Technical Memorandum

Re: 77th Street Underpass Permit Review (LMRWD No. 2020-132)

Figure 1: 77th Underpass Project Location

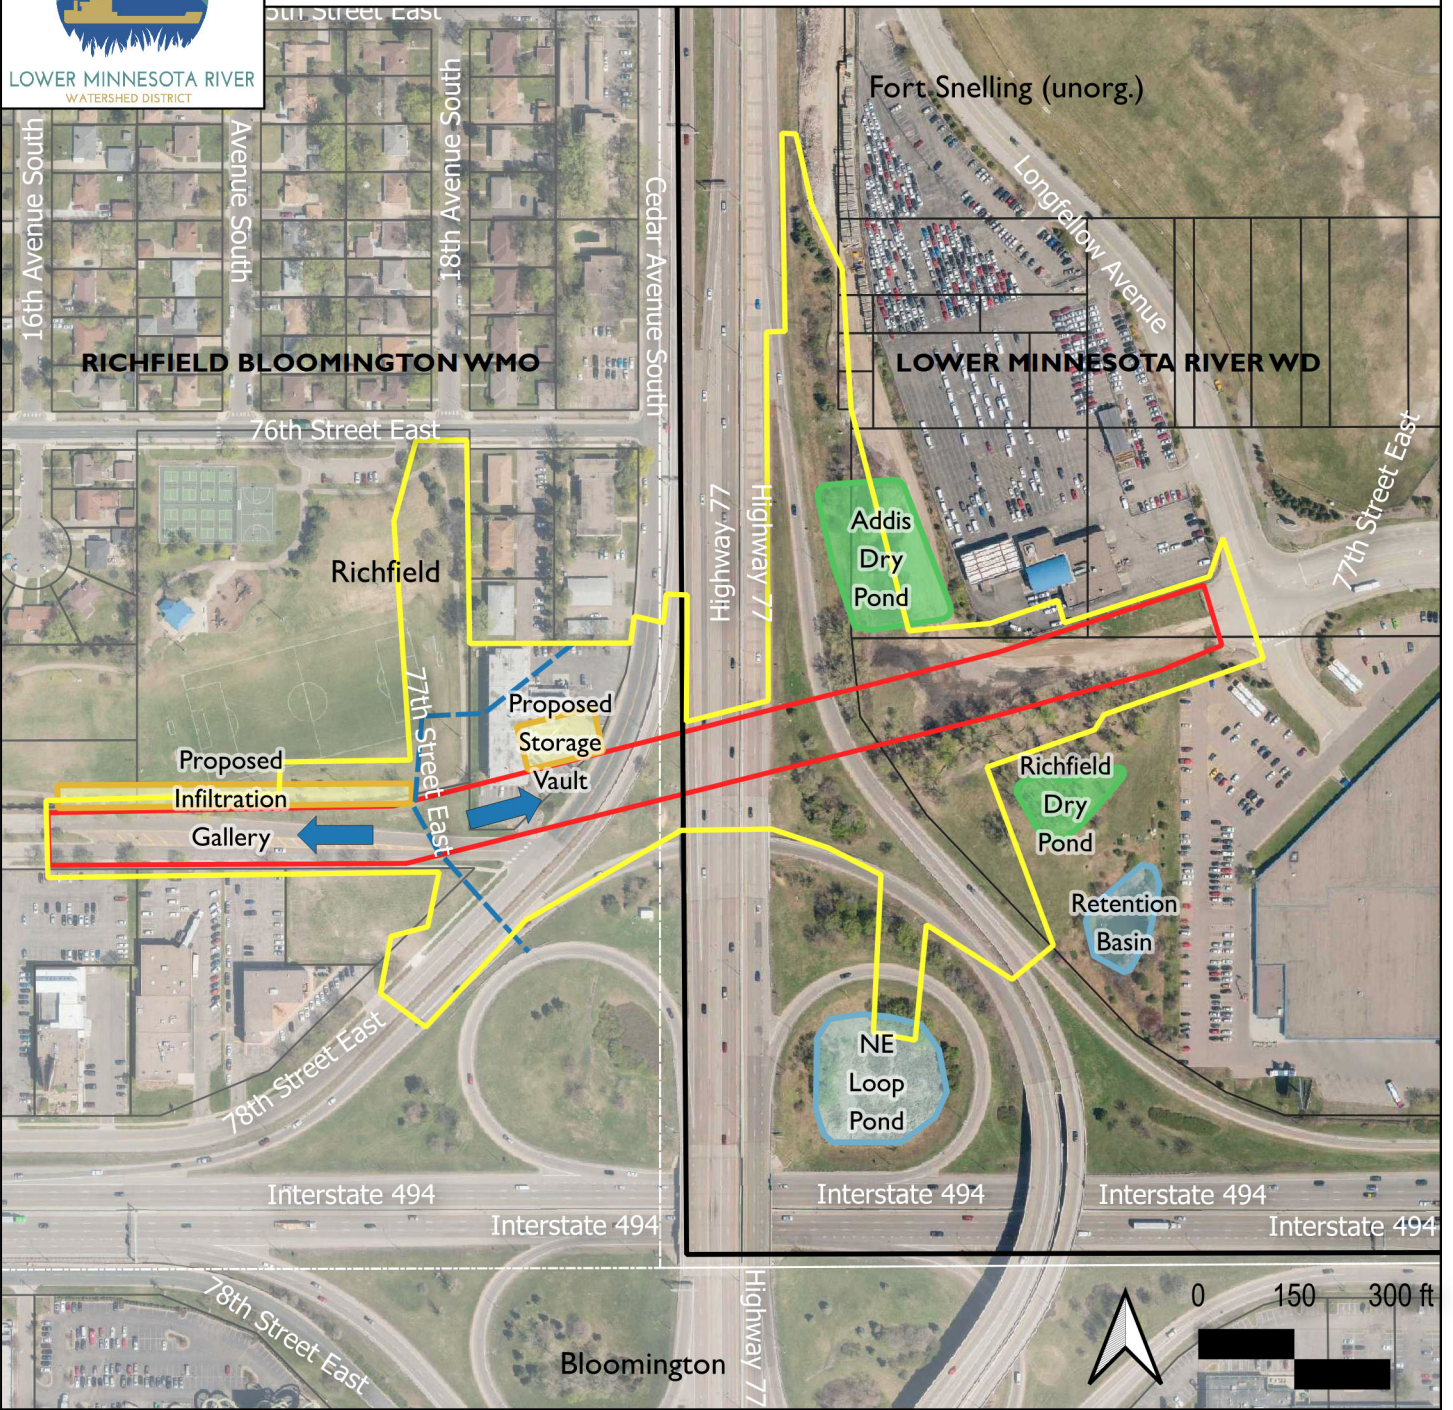
The proposed removal of the dry ponds does not meet the District's volume-reduction and water-quality requirements under Rule D. Additionally, the project appears to involve changing watershed boundaries and redirecting additional area from RBWMO to LMRWD ([Figure 1](#)). District staff have been working with WSB to clarify the project design and ascertain if alternatives were considered to meet the District's requirements.

Figure 2. 77th Street Underpass DWSMA - 11/5/2020

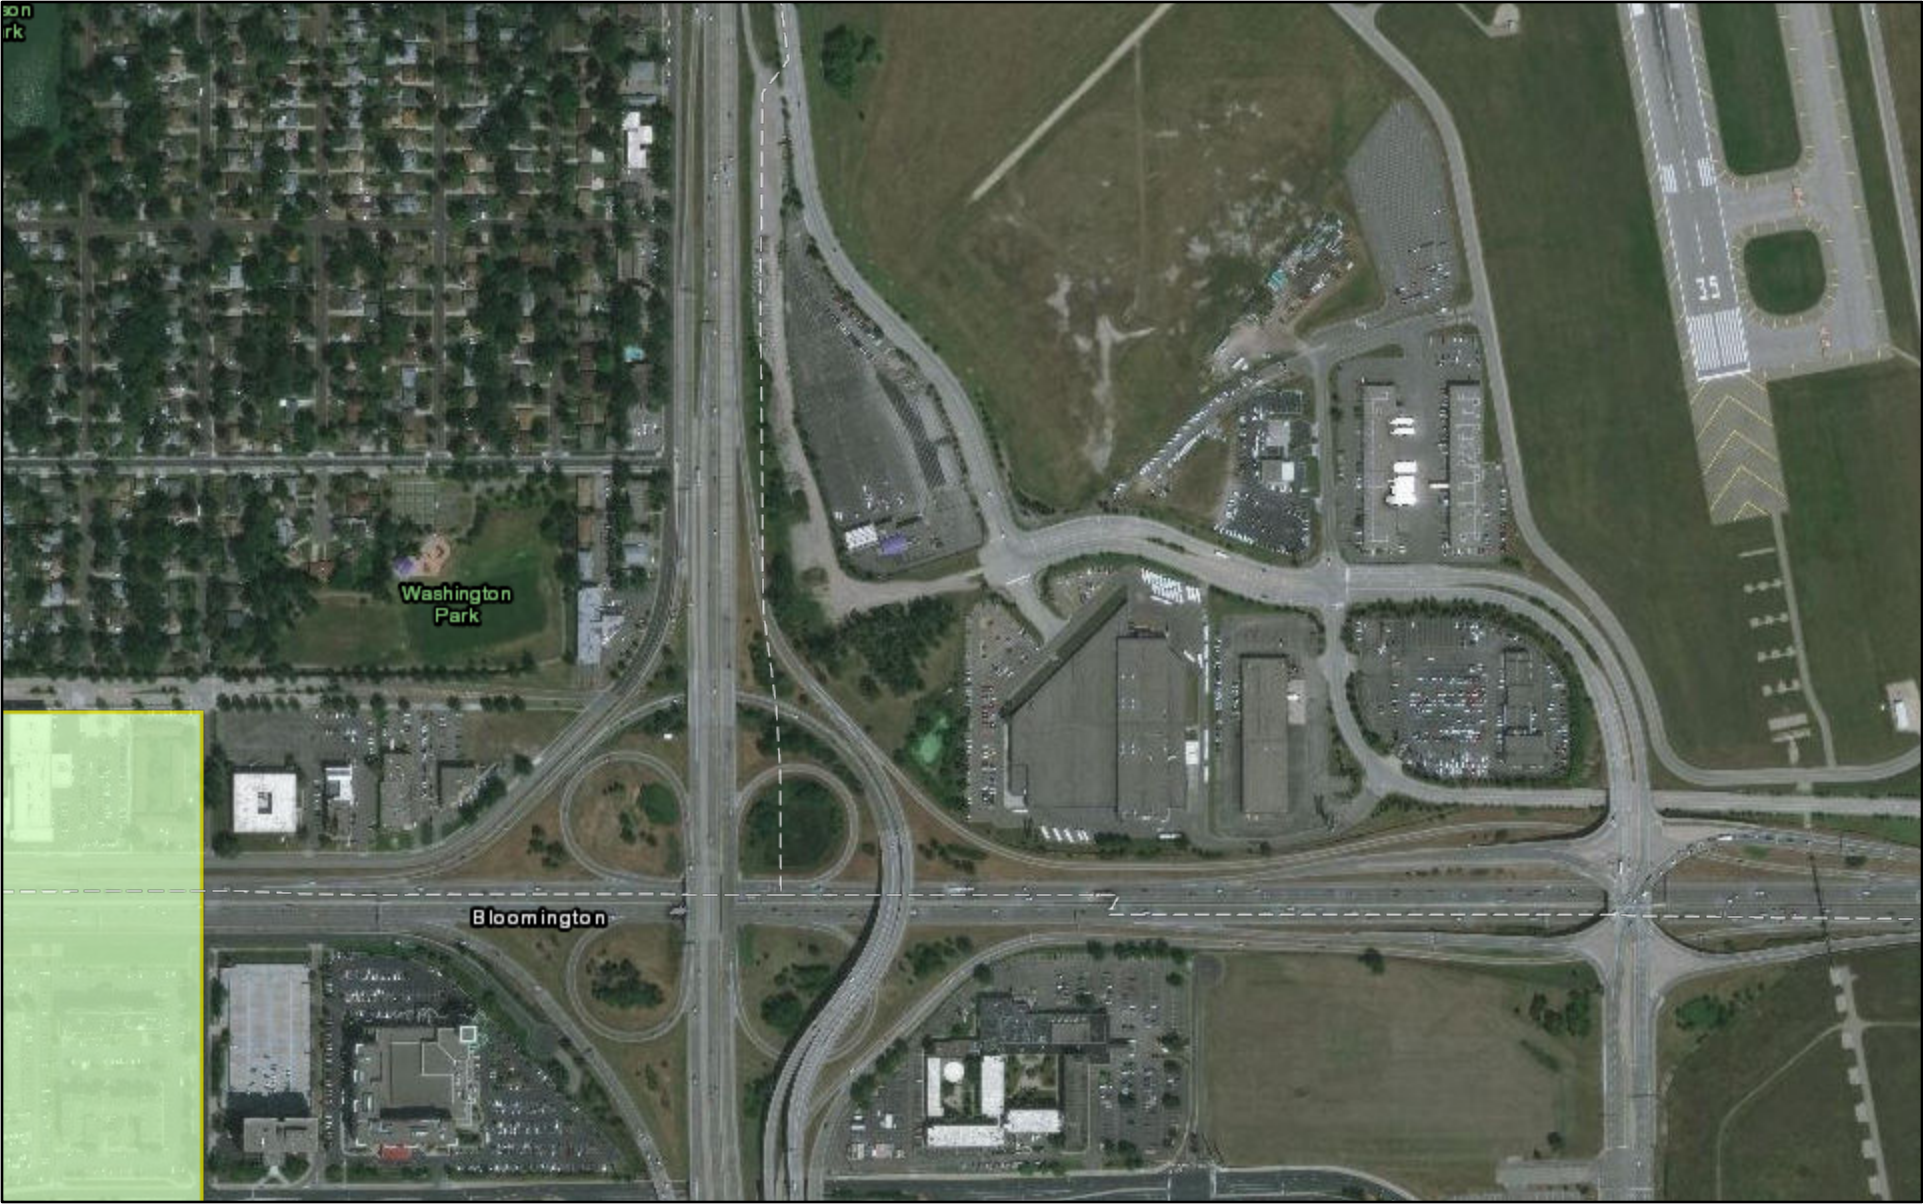
Additionally, the DWSMA boundaries currently shown online by the Minnesota Department of Health (**Figure 2**) do not show the Richfield DWSMA indicated by WSB in their October 21, 2020, memorandum. The District asked WSB for clarification, and WSB confirmed the project no longer falls within the high-vulnerability DWSMA boundary.
